EAGLE MOUNTAIN PLANNING COMMISSION MEETING

March 23, 2021, 5:30 PM

TITLE:	Stonebridge Montessori (Concept Plan)
ITEM TYPE:	Concept Plan
APPLICANT:	Jon Jensen

TITLE:	PUBLIC HEARING - Macey's at Market Place (Site Plan)
ITEM TYPE:	Site Plan
APPLICANT:	Jared Mitchell (Associated Food Stores)

PRE-SCHOOL PLAN
11.03.2021

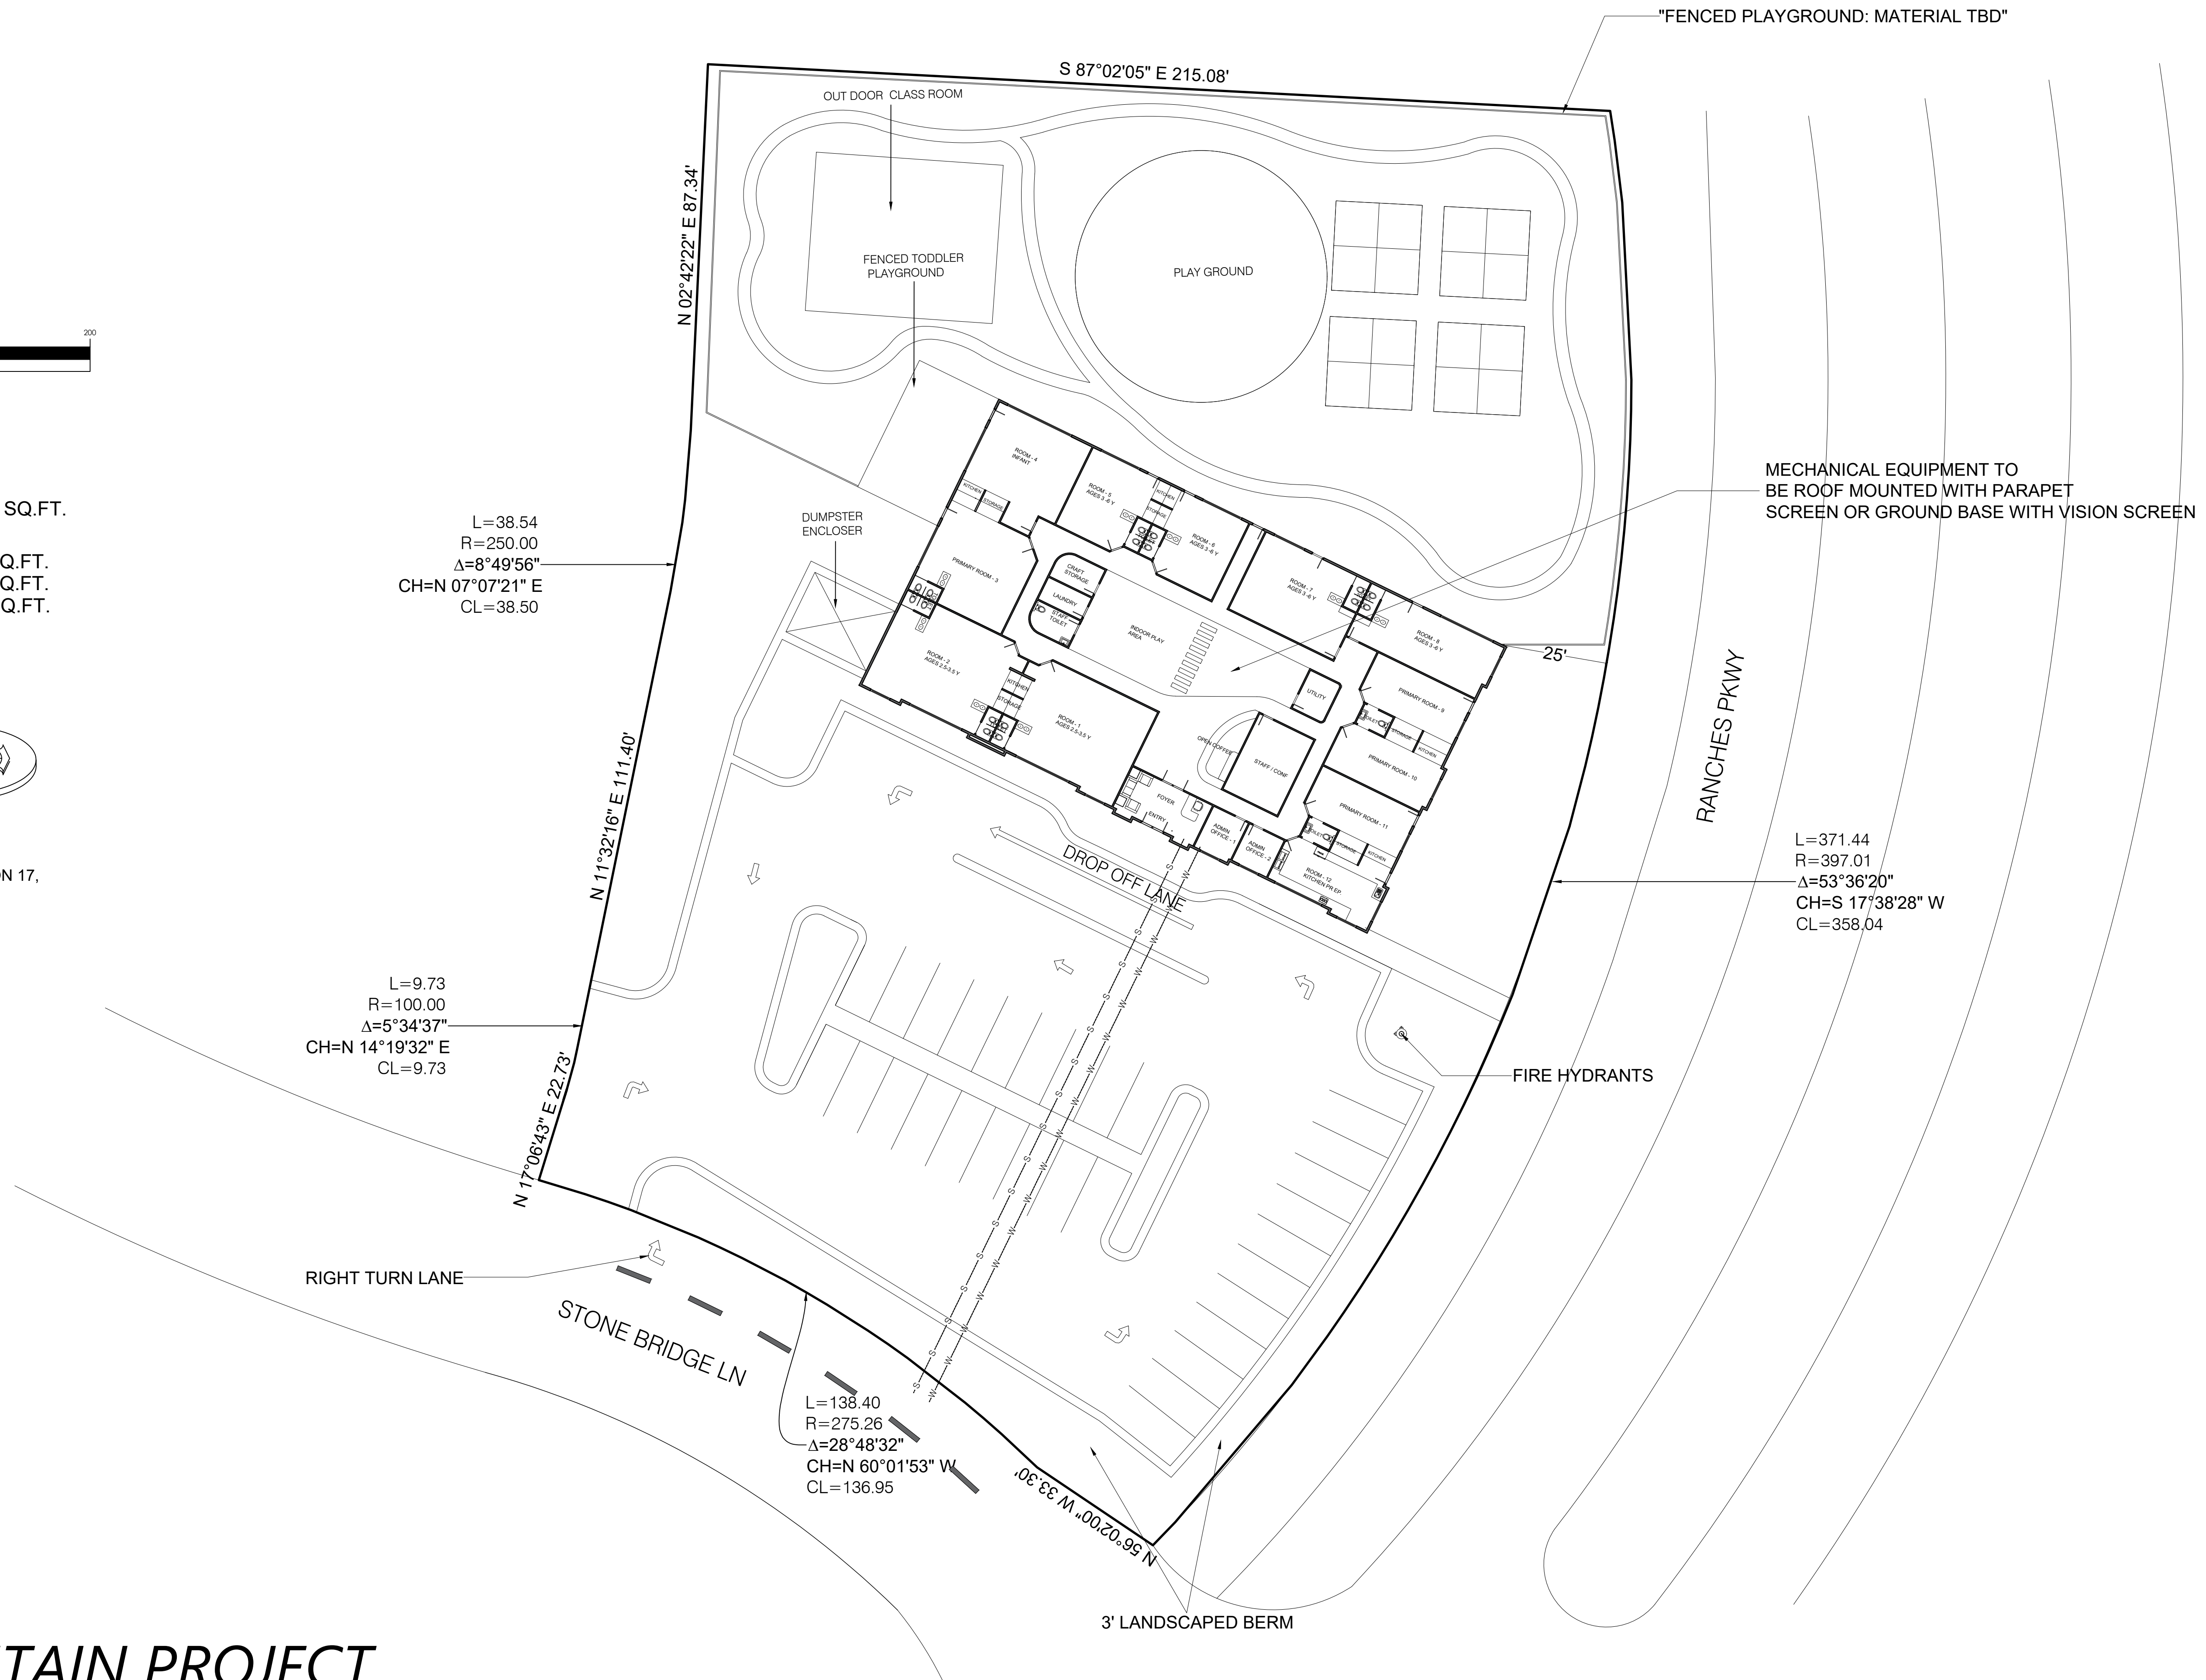
"Commercial buildings should be similar in style as significant adjacent buildings and shall be designed with consistent architectural style, detail, and trim features as the primary façade," per **EMMC 17.72.040 (A)**. Staff recommends the applicant revise the elevations to be consistent with surrounding businesses.

Per **EMMC 17.72.040 (D)**, "buildings shall include façade modulation (stepping portions of the façade), horizontal and vertical divisions (textures or materials), window patterns, offsets, recesses, projections, varied from setbacks or staggered and jogged unit planes within the same structure, and other techniques to help avoid large, featureless and/or panelized surfaces on commercial buildings." Staff suggests the applicant add articulation on the west and north sides of the building to come into compliance with this code.

The school will be accessed from E. Stonebridge Lane. Staff has recommended to previous applicants interested in this lot that they collaborate with the property owner to the west to create an access road along the west property line to benefit both properties and run to the north which would provide access to this property's parking lot. This would also increase the distance from the access point to the intersection of Stonebridge Lane and Ranches Parkway. The applicant has the access point to the western-most edge of the property and should work with the adjacent property owner on potential cross access needs.

"Headlight screening is required around the perimeter of all areas adjacent to residential uses, or as deemed necessary by the planning director. A headlight screen shall consist of a berm, fence wall, or landscaping consisting of at least three and one-half feet in height and capable of blocking headlight glare (**17.55.040 (G)**).\" The concept plan does call for a three (3) foot landscape berm. Staff recommends the applicant add a half-foot to this berm to come into compliance with this code.

The parking requirement for preschool is 1 stall per staff member plus 1 stall per 10 children. The concept plan shows 30 spaces. **Per 17.55.120(b)**, two of these spaces would need to be ADA-compliant and located as close to the school building entrance as possible.

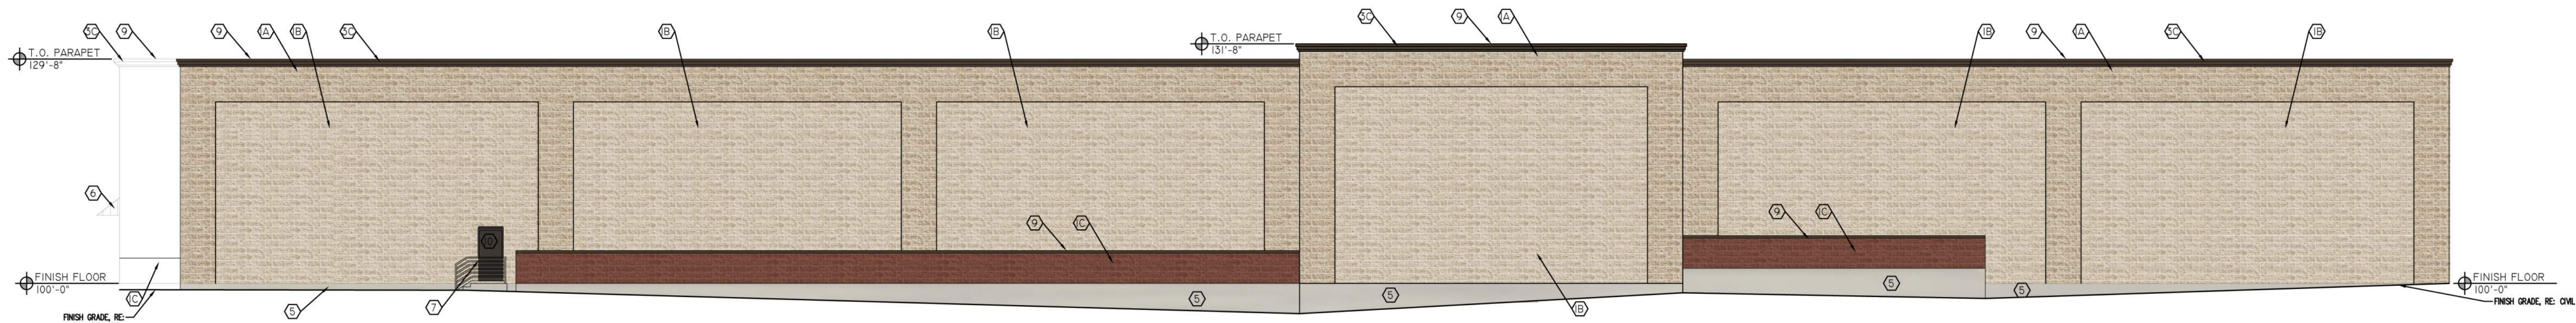
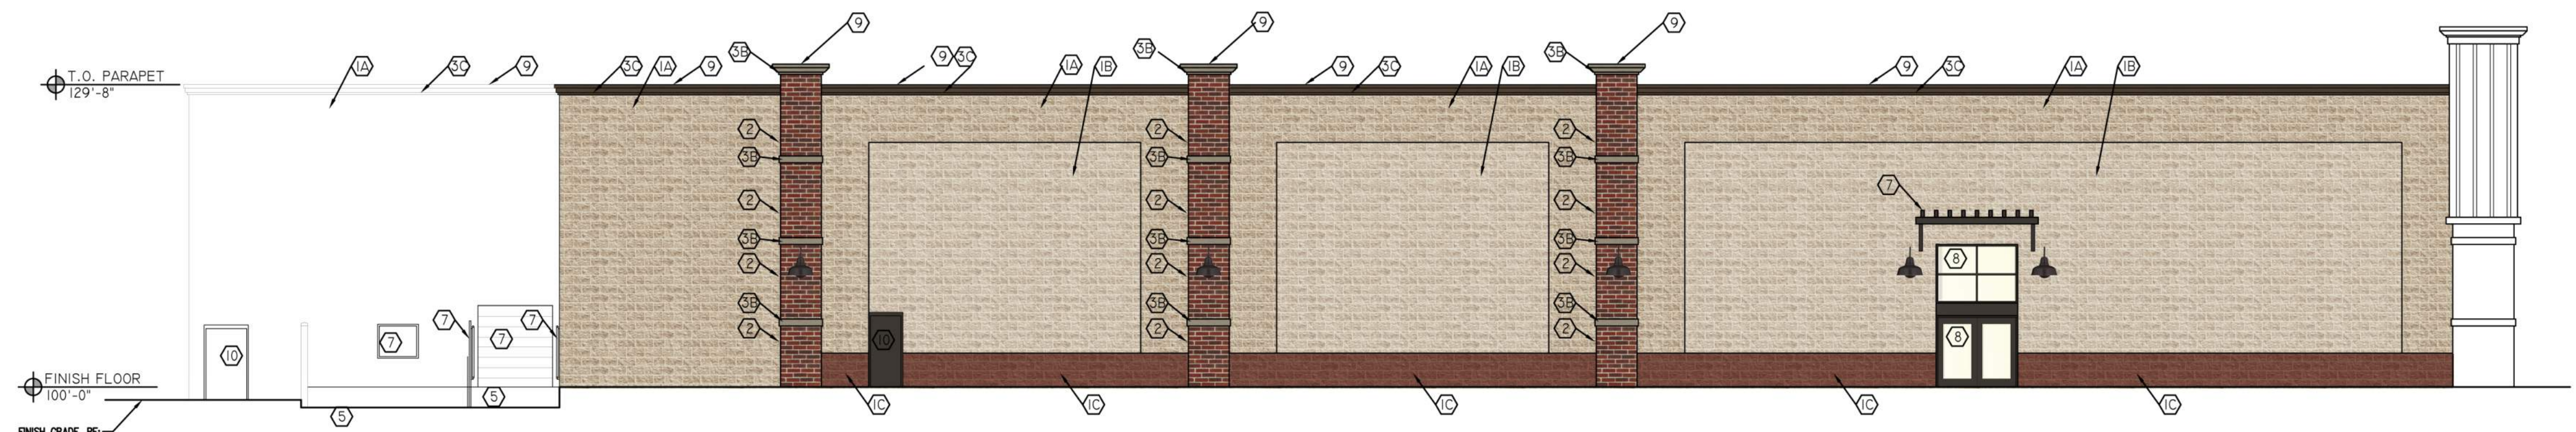
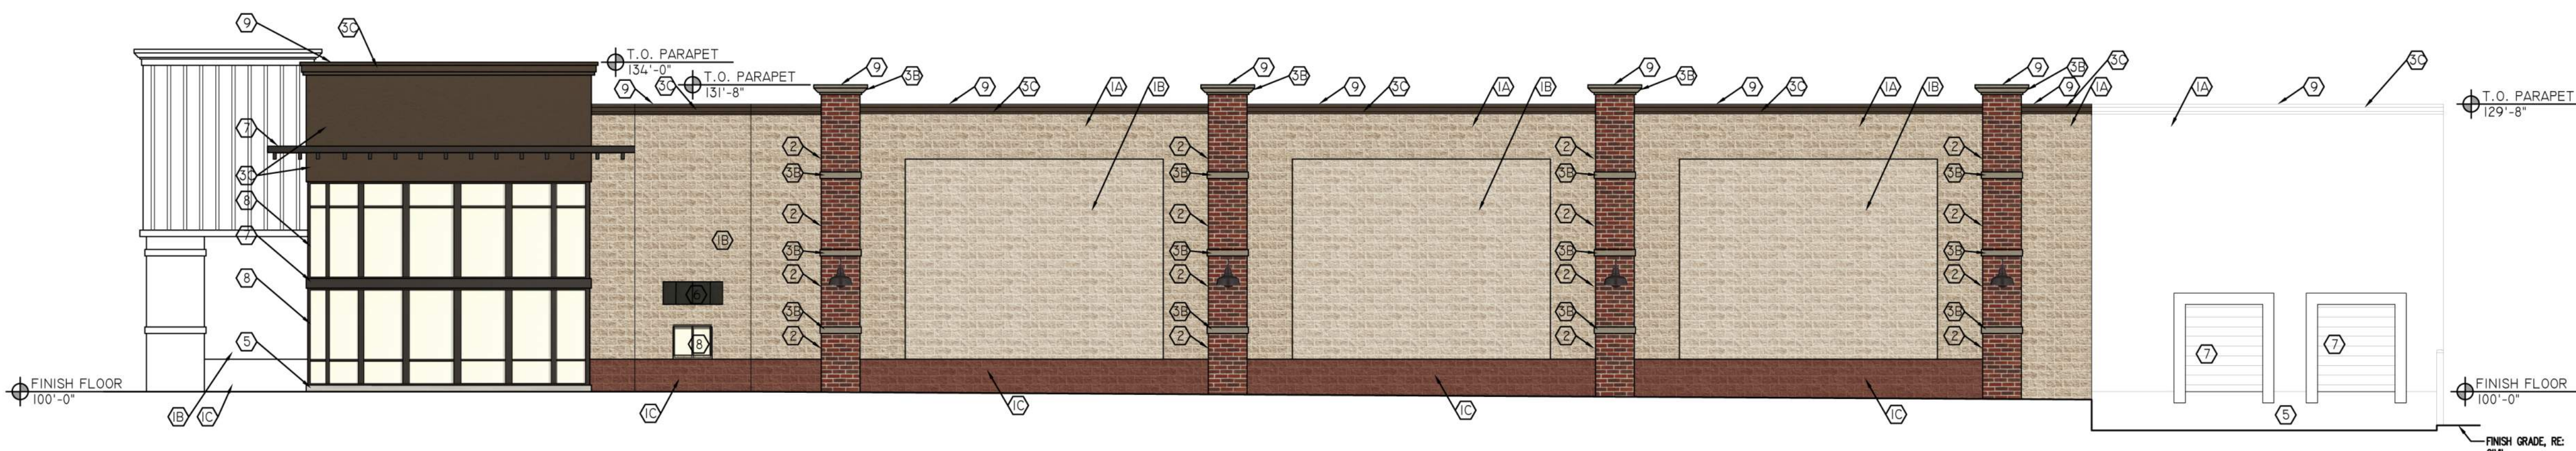
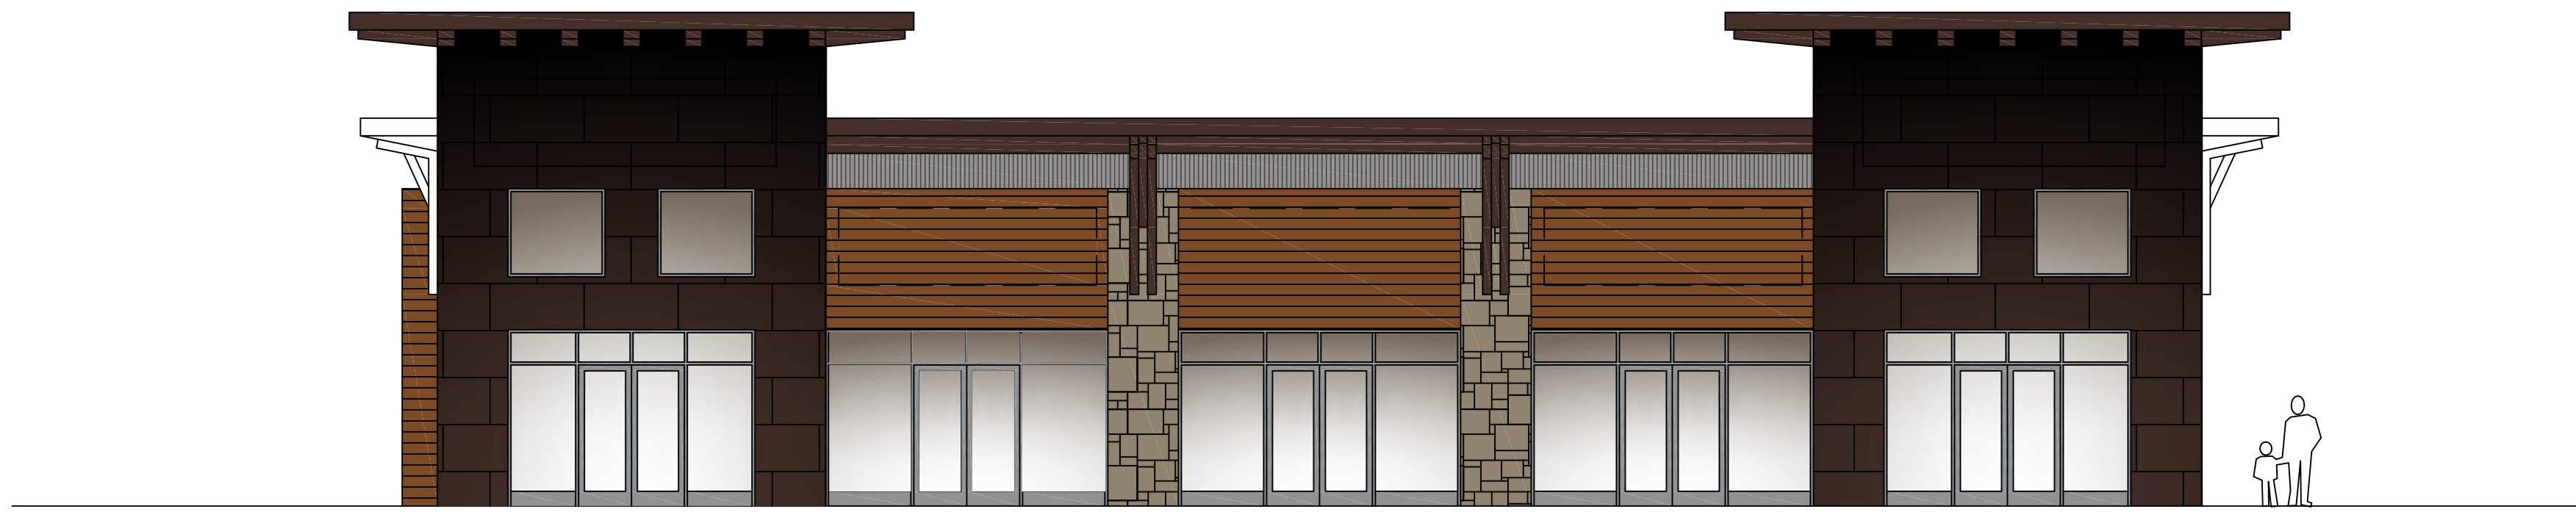
- **17.100.060 B** states “windows are encouraged as accents and trim.” The proposed elevations provide windows on the south elevation and the south-east corner of the building, and over the entrance on the west elevation. It is up to the Planning Commission to determine if the provided elevations comply with this portion of code.

Per **17.72.040 C** states “The primary roof form of a structure should help reduce the perceived scale of the building. All commercial buildings shall contain either sloping roofs with overhanging eaves, or a decorative parapet and multiple roof planes and heights. Decorative cornices and roof projections such as cupolas or towers are also encouraged.” It is the opinion of staff that the *South and East Elevations* comply with this standard, however, the North and West elevations should be amended to contain different roof planes.

17.72.040 D states “...Buildings shall include façade modulation (stepping portions of the façade), horizontal and vertical divisions (textures or materials), window patterns, offsets, recesses, projections, varied front setbacks or staggered and jogged until planes within the same structure, and other techniques...to avoid large, featureless and/or panelized surfaces on commercial buildings. Large uninterrupted expanses of a building wall are prohibited.” The *South Elevation* complies with these standards, however, additional articulation is required for the *North, West, and East* elevations.

17.72.040 E states “Commercial buildings shall incorporate a majority of the following architectural details: reveals, canopies, awnings, popouts, columns, decorative trim and moldings, architectural lighting, ornamental cornices, decorative masonry pattern, decorative doors and windows, exposed timbers and trellis structures. All sides of a building shall include the chosen details.” The Macey’s elevations include awnings, columns, architectural lighting, and decorative doors/windows, thus providing four of the 12 elements. An additional three architectural features shall be added to all four sides of the structure to come into compliance.

materials on all sides, including brick, rock, fiber/cement siding, wood, glass, stucco, and colored architectural CMU. Stucco may not be used on more than 50 percent of a building. Metal, plain CMU, or other materials deemed appropriate by the Planning Commission and City Council may be used as accents only.” The North and West elevations feature large, panelized sections. Additional features shall be added to the north, west, and east elevations.

1. Additional windows be added to the elevations in compliance with 17.100.060 B.
2. All parking lot lights shall be no more than 17' in height from grade.
3. Elevations shall be updated to use similar materials, and design elements as the approved Pad site elevations and the Shops at City Center.
4. North and West elevations should be amended to contain varied roof planes.
5. Additional articulation and material variation shall be provided for the north, west, and east elevations.
6. An additional three architectural detail features shall be used on all four sides of the structure.
